TOWN OF BAY HARBOR ISLANDS

SPECIAL COUNCIL MEETING AGENDA

June 29, 2022 – Approximately 7:00 P.M.

ITEM: Consideration and Approval of an application for an appeal to the Town Council of the Town of Bay Harbor Islands, Florida of a June 7th, 2022 decision of the Design Review Board, denying an application by Bay Harbor Islands Property Owner II, LLC for Site Development Plan Modification pertaining to development at 9431, 9461, and 9481 East Bay Harbor Drive, Bay Harbor Islands, Florida. Enclosed are supporting documents.

Sheet No.
A-103.2

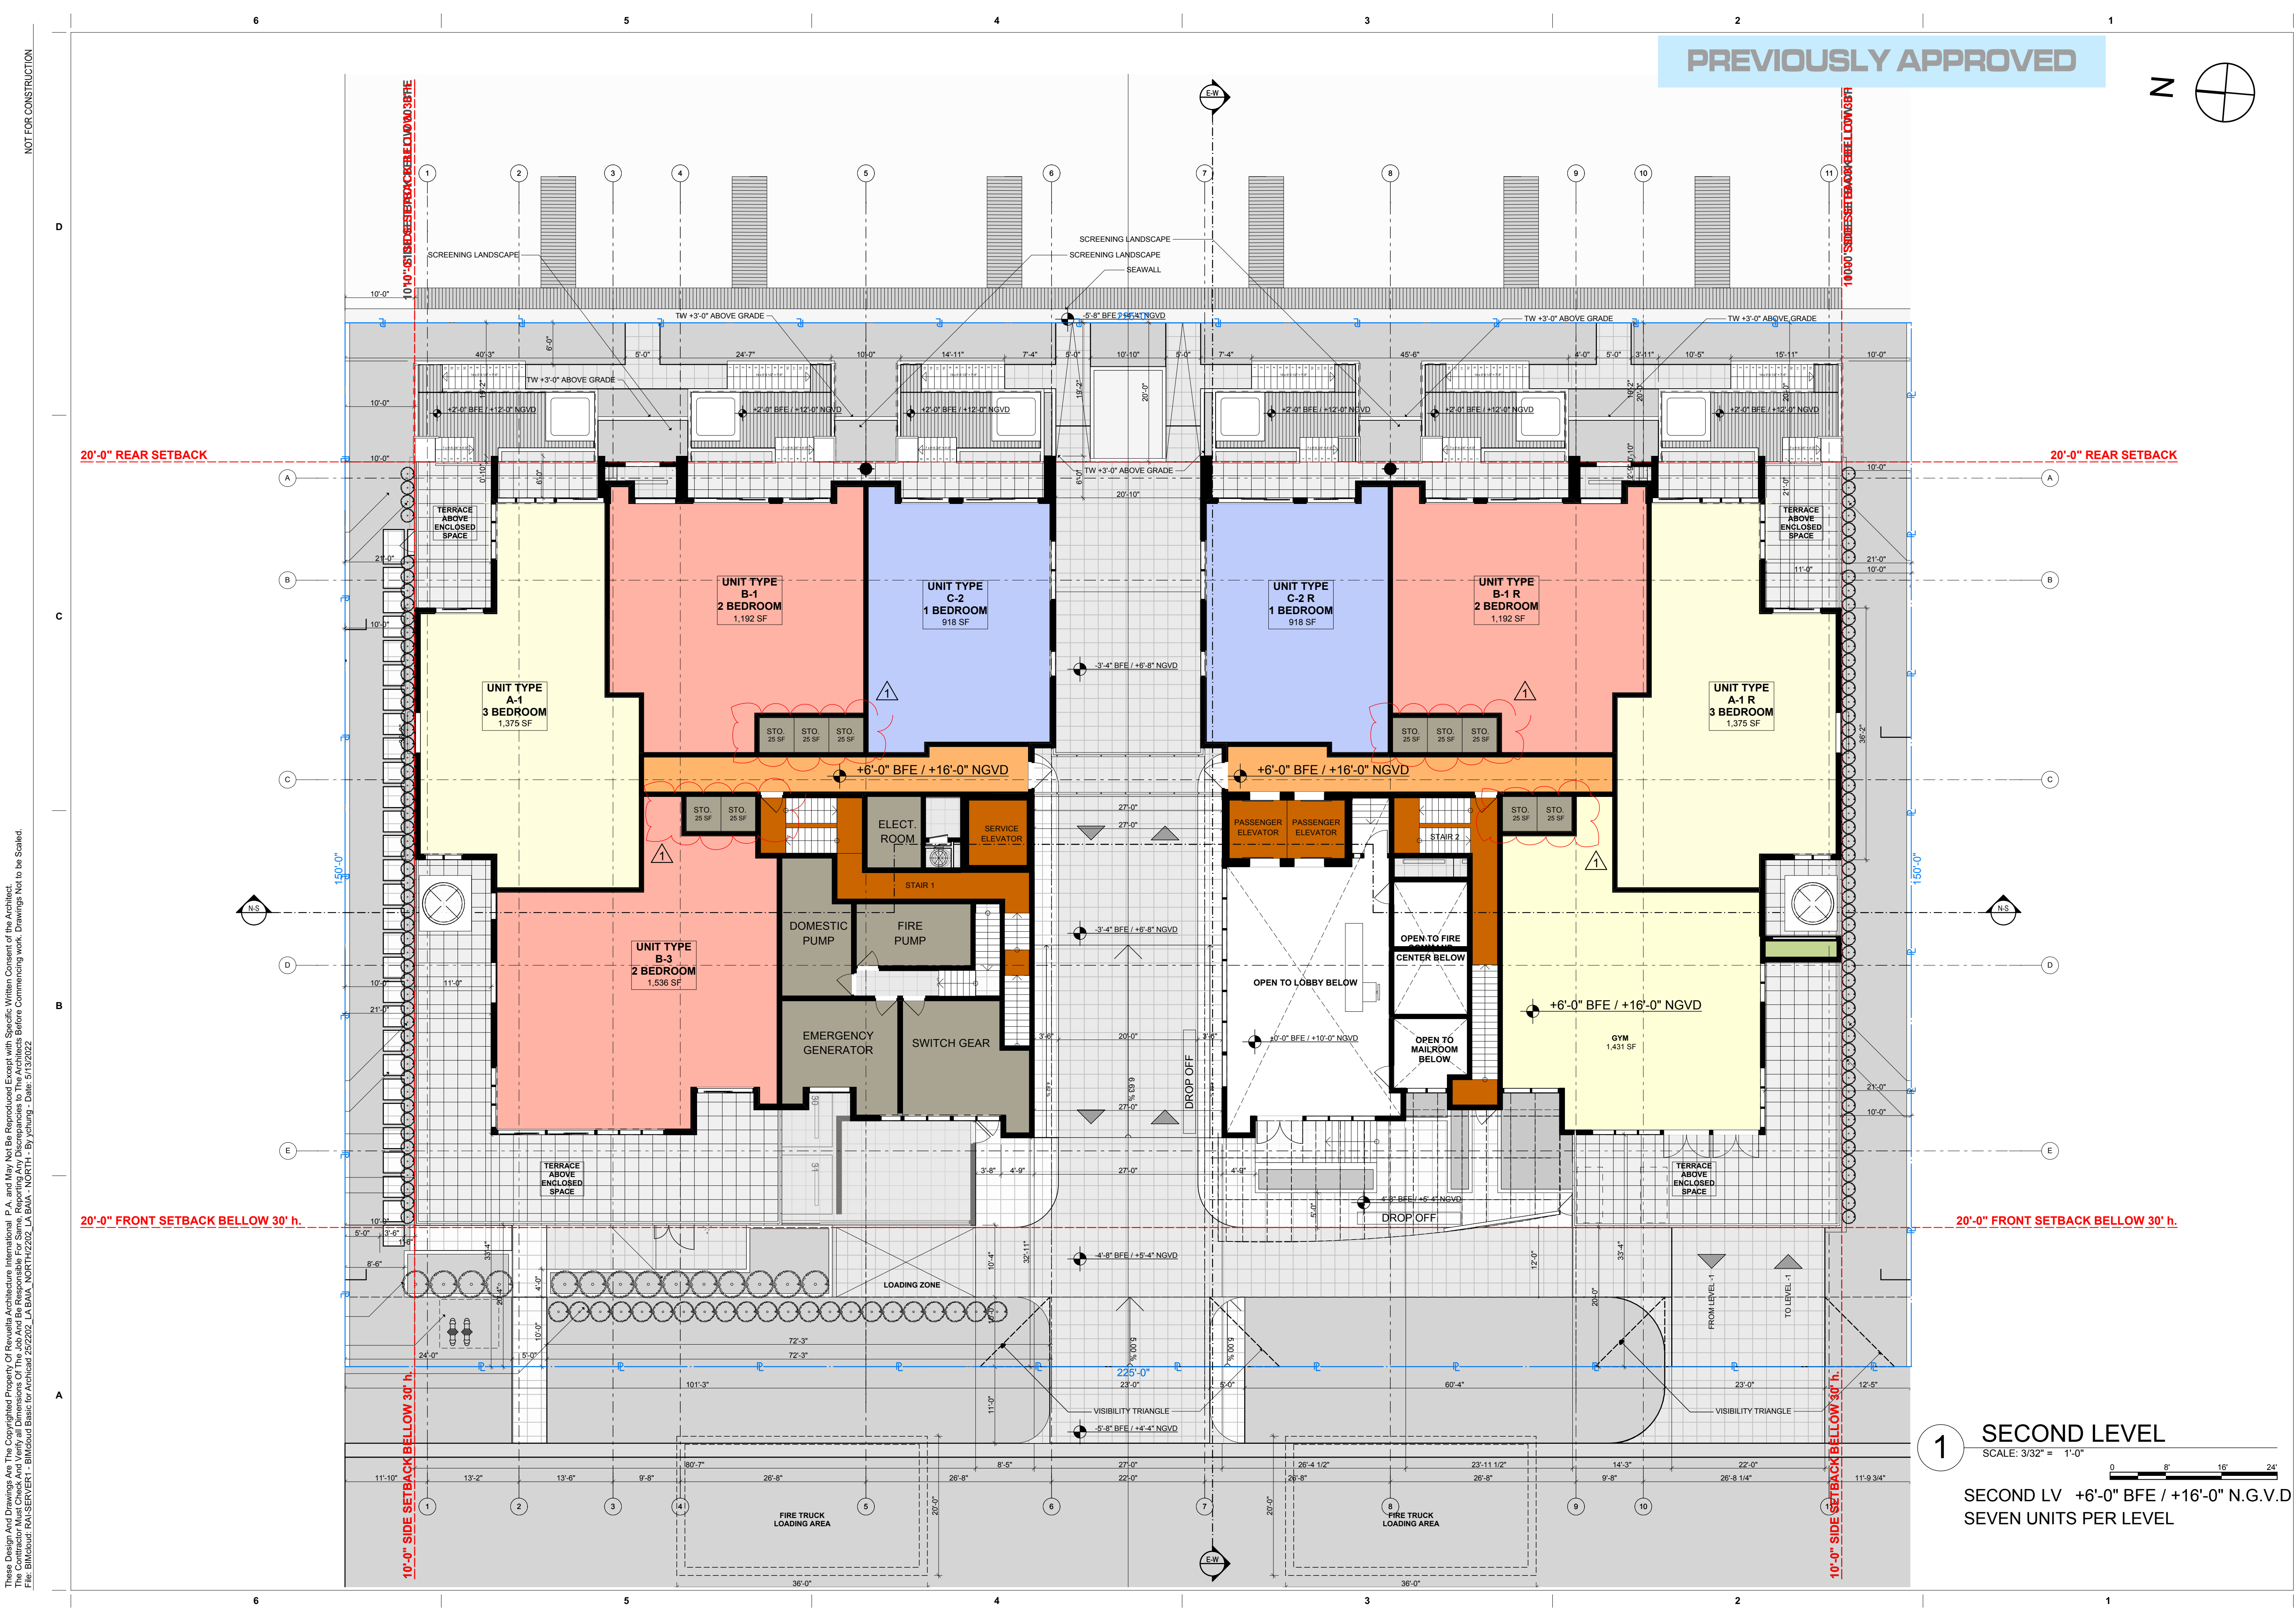
On page A-103.2 First Level Site Plan (and several other plan sheets) a new pedestrian walkway has been added in the front yard - which is acceptable - but no dimension of the walkway width is provided. Sec. 23-12(15) limits the width of such walkways to no more than 5'. Verify / correct the proposed width and add a dimension to the plans.

On page A-103.2 First Level Site Plan (and several other plan sheets) proposed Fire Truck staging areas are shown on the plans. One is in the throat of the southerly driveway (acceptable). However, the other is shown centered on the site encroaching partially into the roadway swale - which must be landscaped and include Street Trees per M-D / Town. Landscape Codes - so a conflict will occur. Relocate the proposed staging area out of the swale completely to the north driveway or other location. The building will most likely be fully sprinklered easing the need to for staging (pumper / aerial ladder truck).

R: Yes, flood vents are provided, see sheet A-103.2. item #14 in the Summary of Proposed Architectural Modifications.

R: See sheet A-103.2; there is a lift connecting de Lobby and the drop off and then a path crossing the driveway and a walkway to connect to the street.

R: It is planned as one-way, see sheet A-103.2.
